INITIAL FIRE SAFETY INSPECTION REPORT

Eusebio Sporting (Bangladesh) Limited

RSC ID: 11628

Date: 08-February-2024

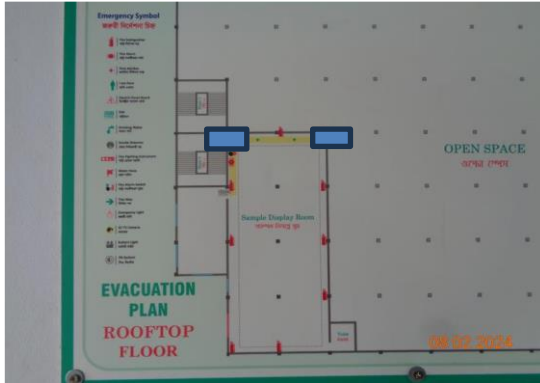
F-07	Fire Rated Construction	Exit capacity is not adequate for the occupant load on the 1st floor (building: 03), in addition, the dining area accommodates over 300 occupants and shares the same building & exit stairway with stores that do not meet the requirements outlined in BNBC 2006 table 3.2.1. Location: Building: 03	Limit the occupant load capacity to 300 or below. Or, Relocate the dining ensuring RSC Technical Guidelines (Standard) ¹ V1.0, section 6.4 and BNBC 2006, chapter 2 part 3, table 3.2.1 and chapter 3 part 4, section 3.21.3.	Immediately
------	-------------------------	---	--	-------------
